CHANGE ORDER 135
INSTRUCTION BULLETIN
DEFERRED APPROVAL
DO NOT SIGN

PROJECT NAME
**CHILDREN'S HOSPITAL
OF ORANGE COUNTY**
455 S. Main St.
Orange, CA 92668-3874

LEVEL 2 REFLECTIVE
CEILING PLAN - AREA P

A4.2P
CO # 135

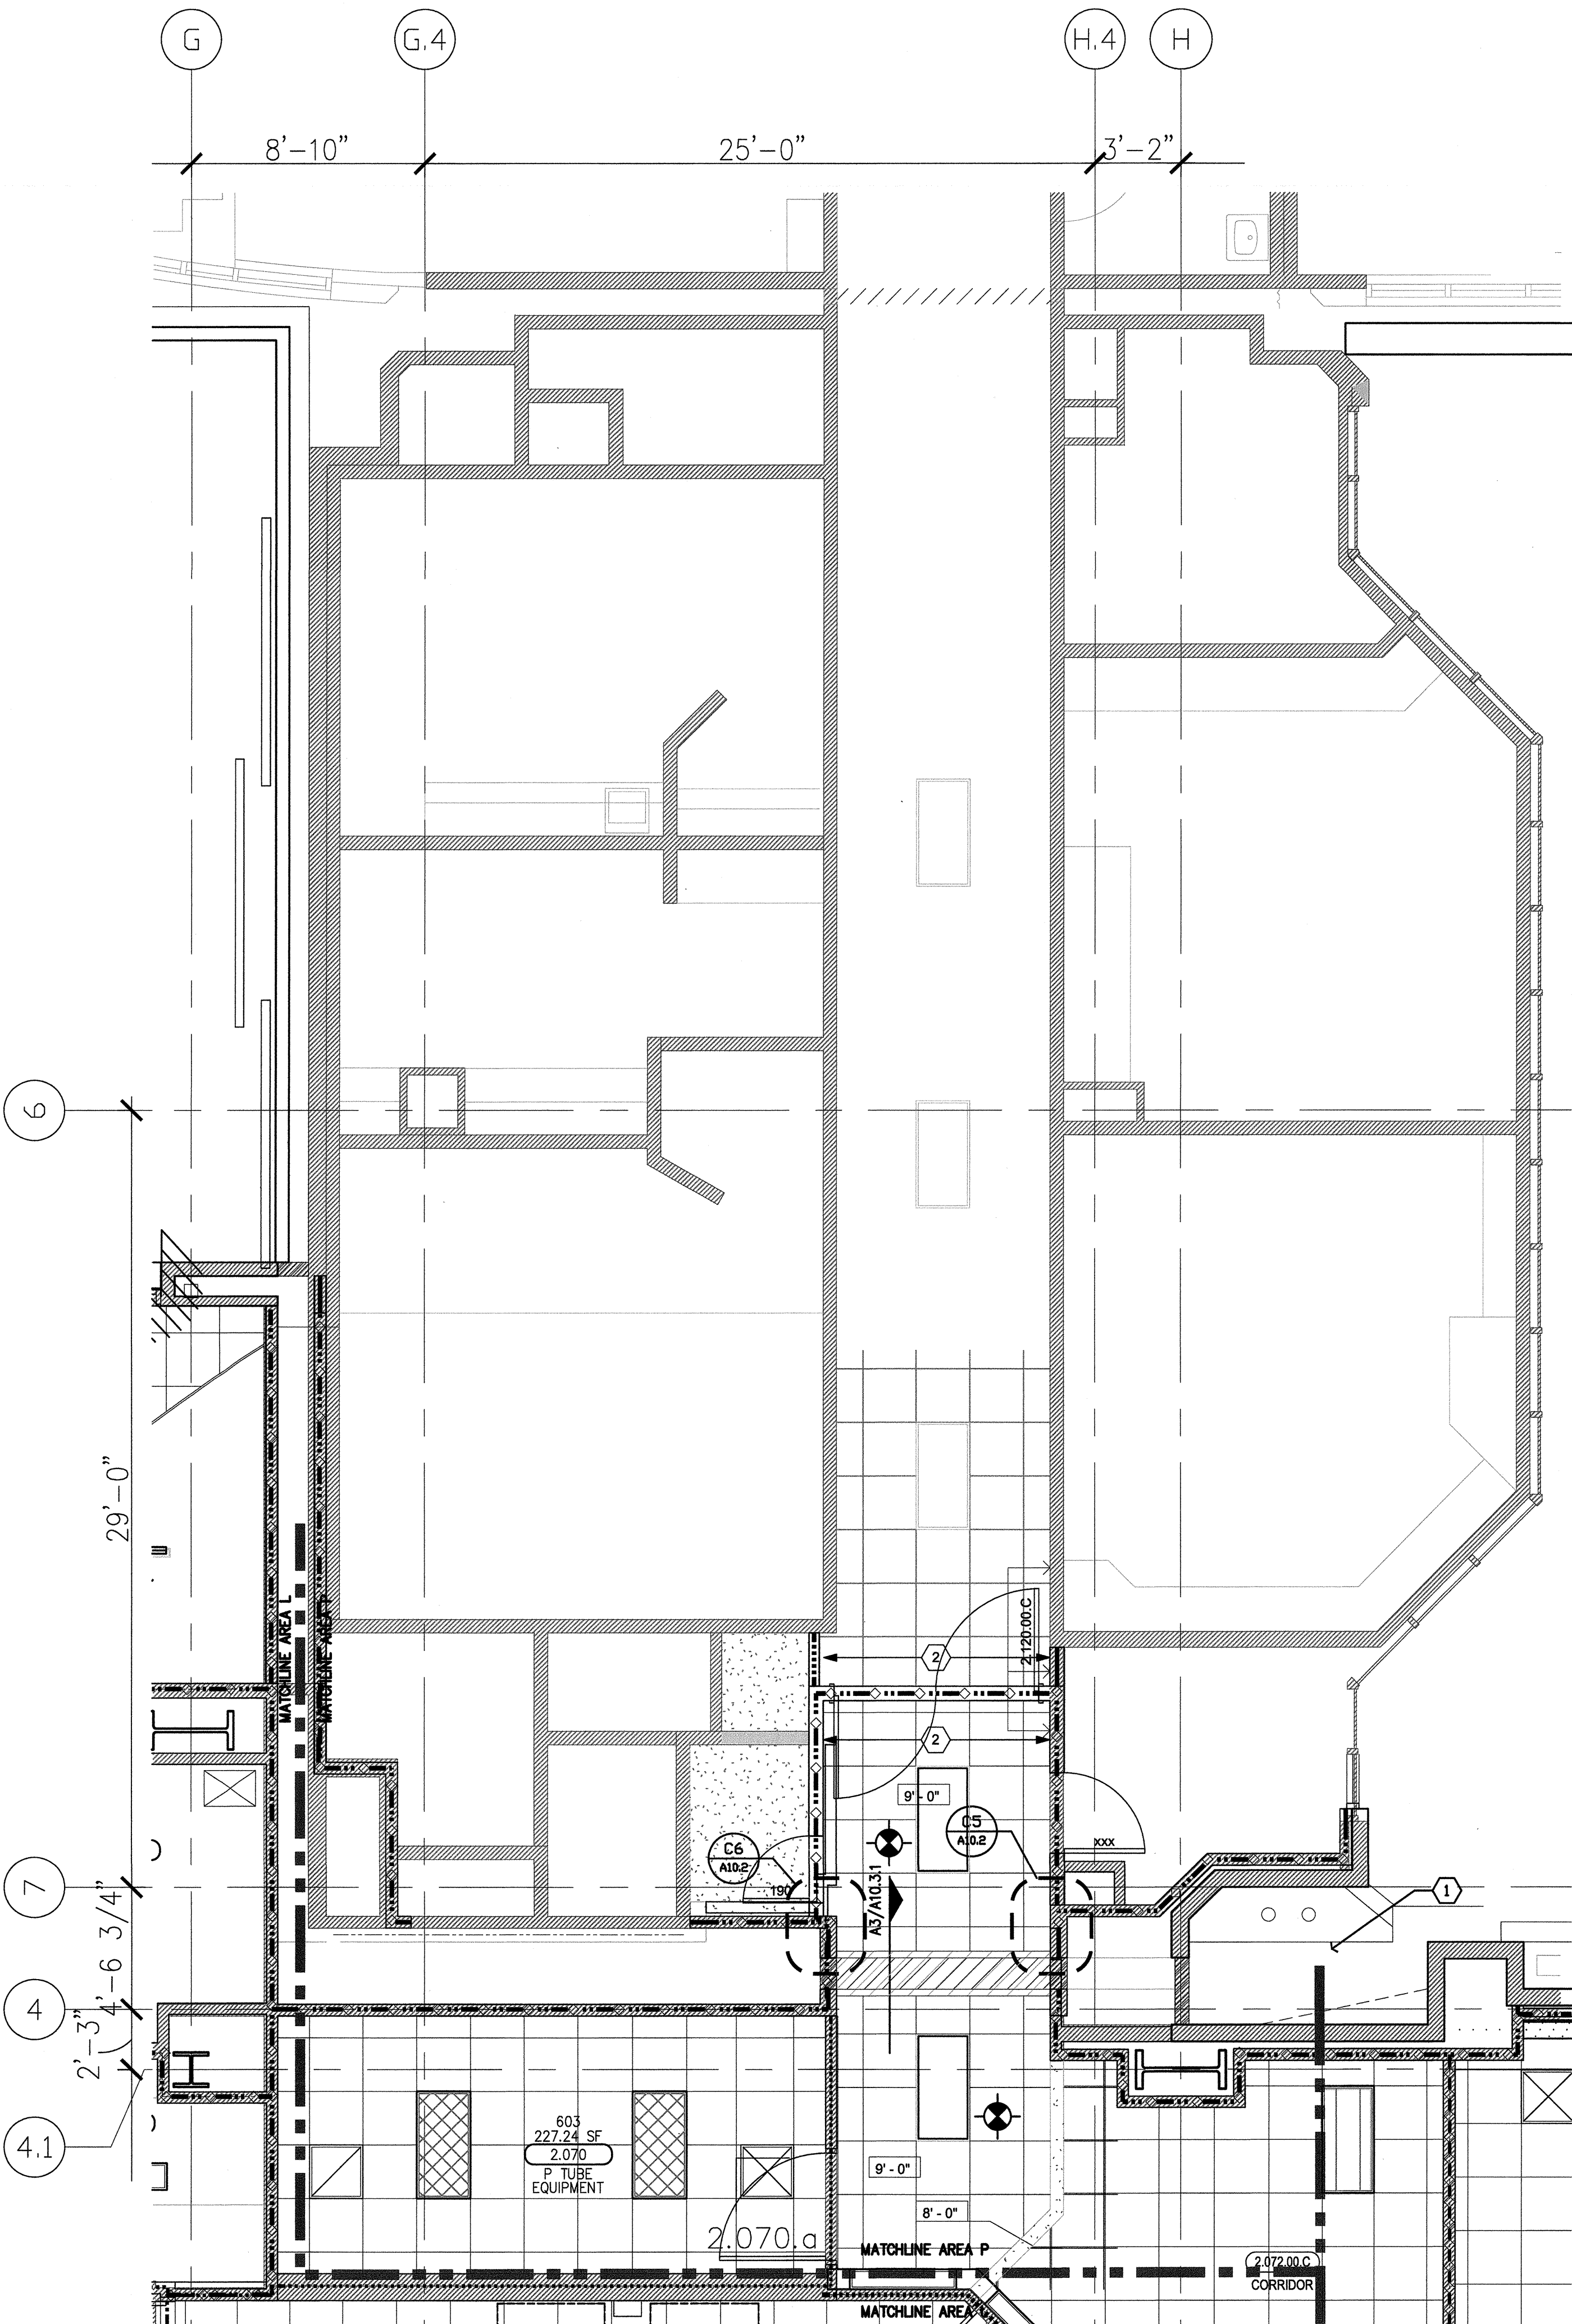
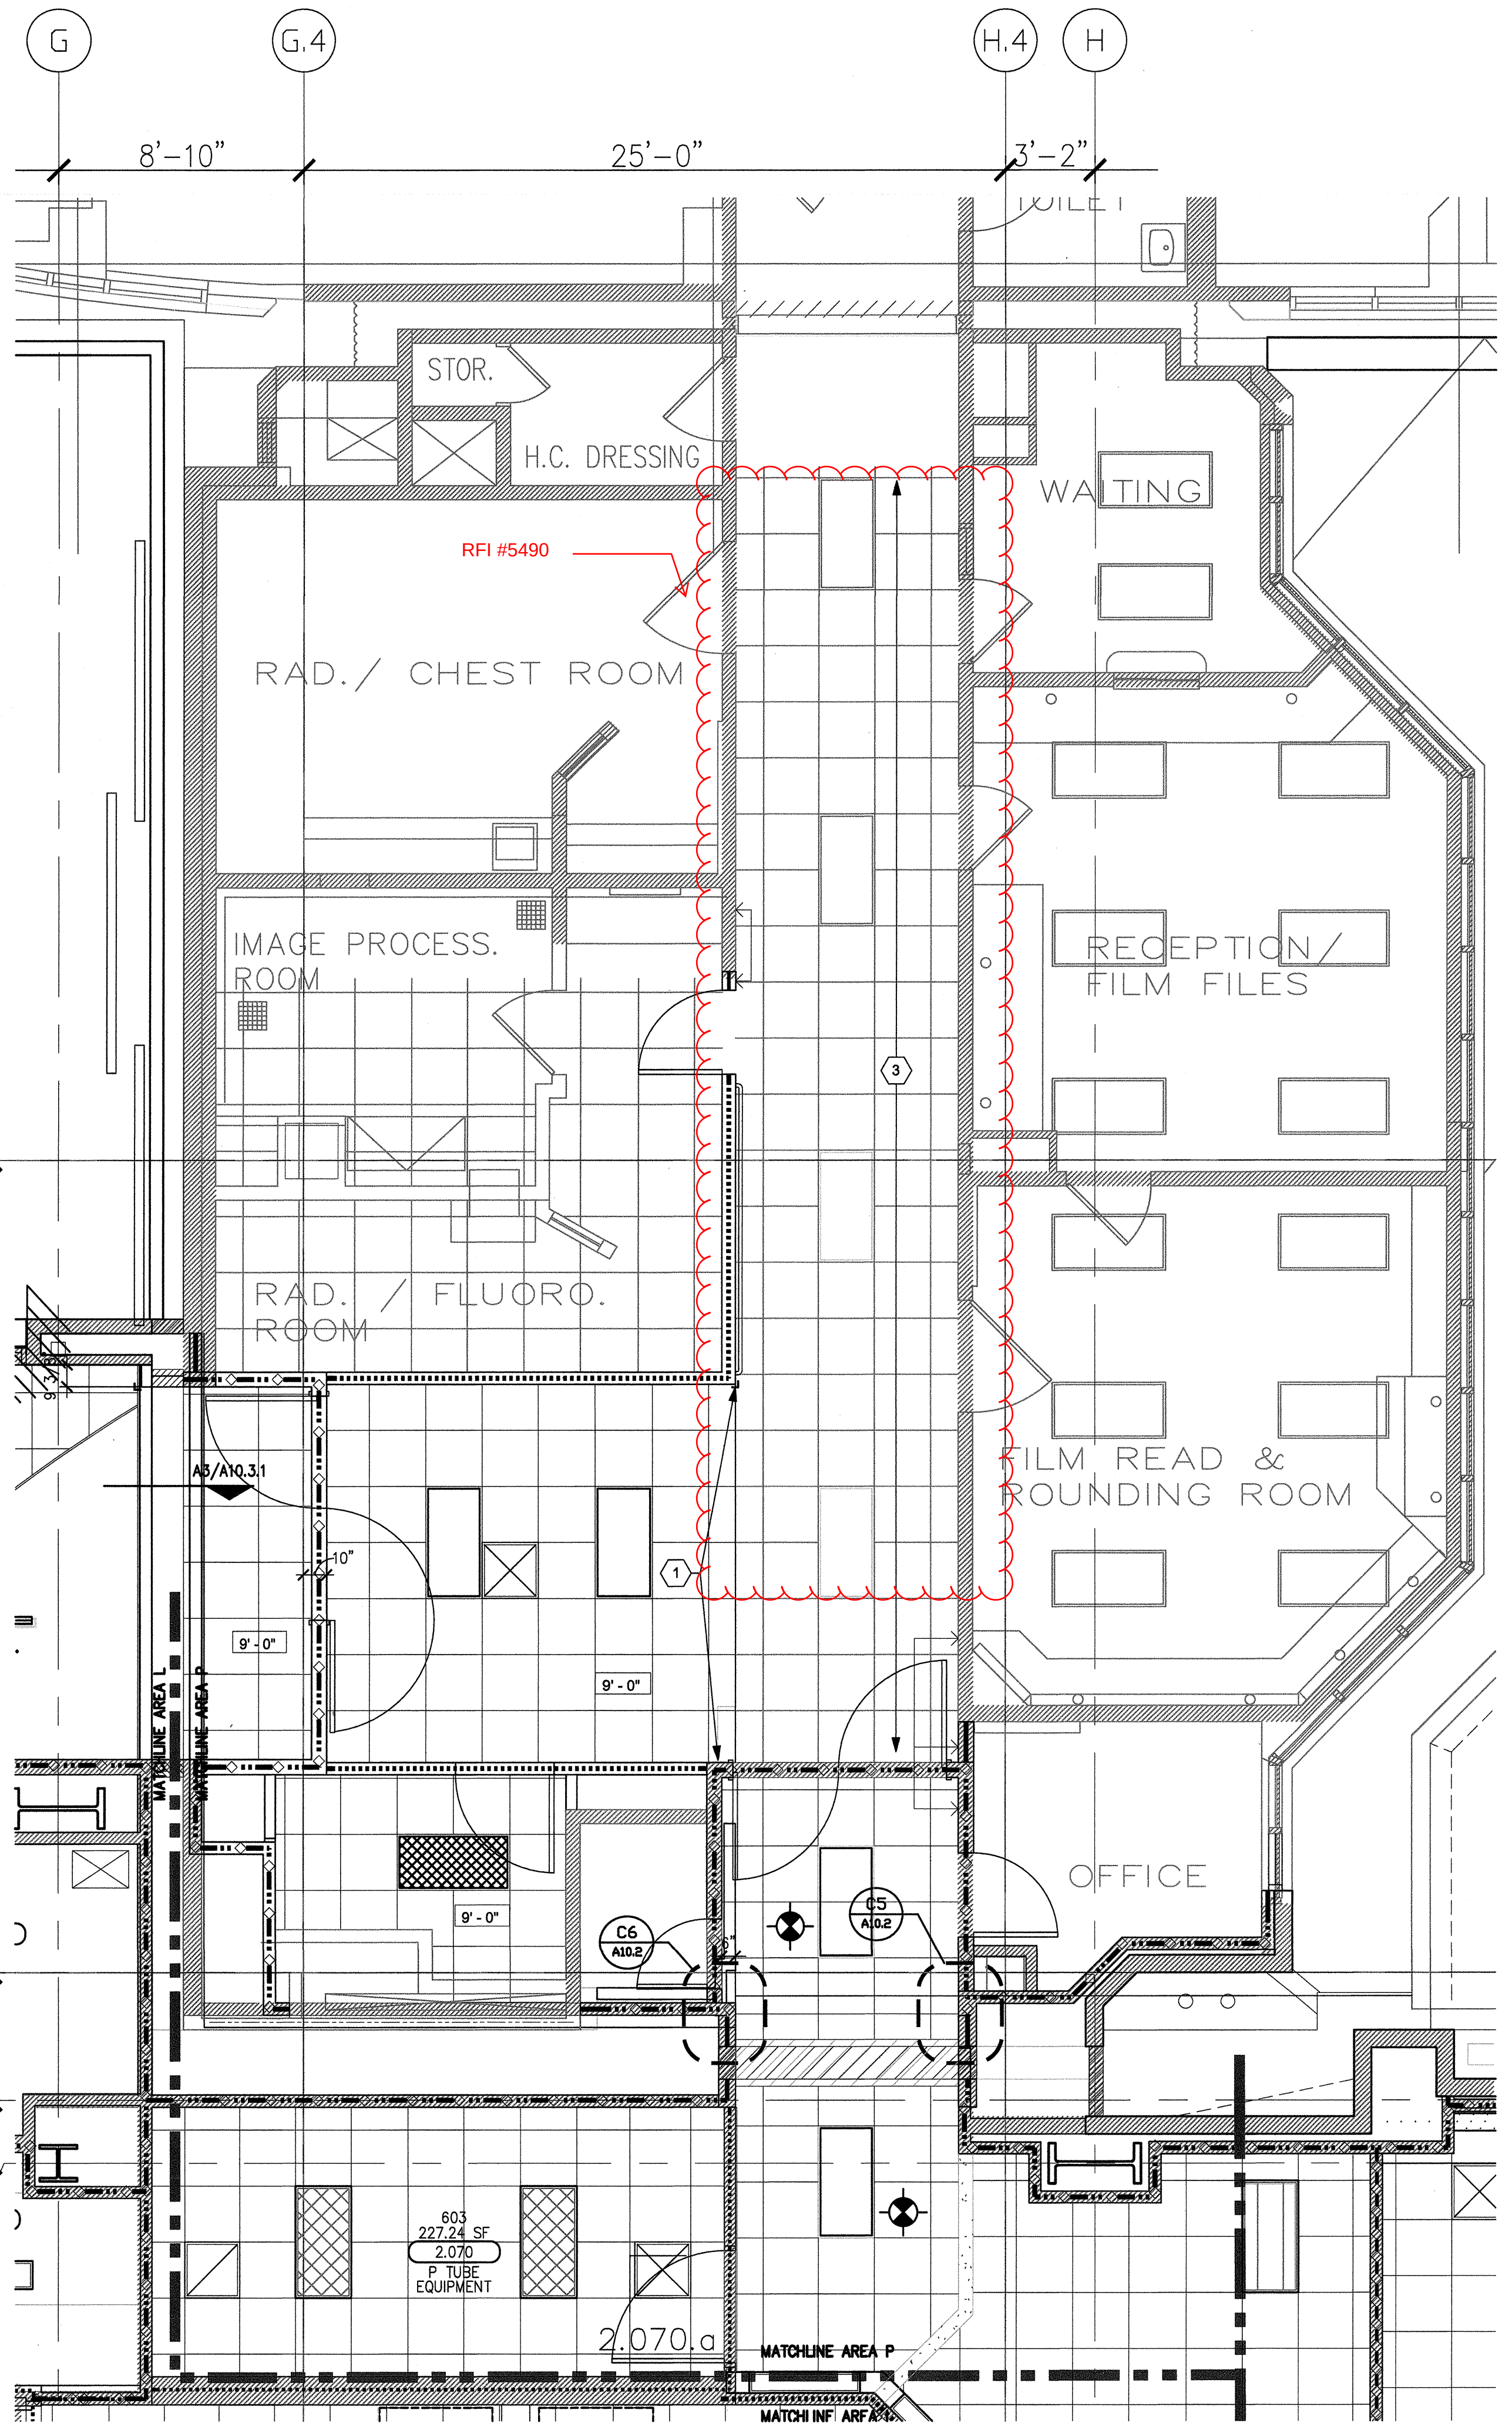
1. INSTALL CEILING TO ALIGN WITH EXISTING SYSTEM.
2. MODIFY CEILING AS REQUIRED TO RECEIVE NEW DOOR HEADER.
3. EXISTING CEILING TO REMAIN.
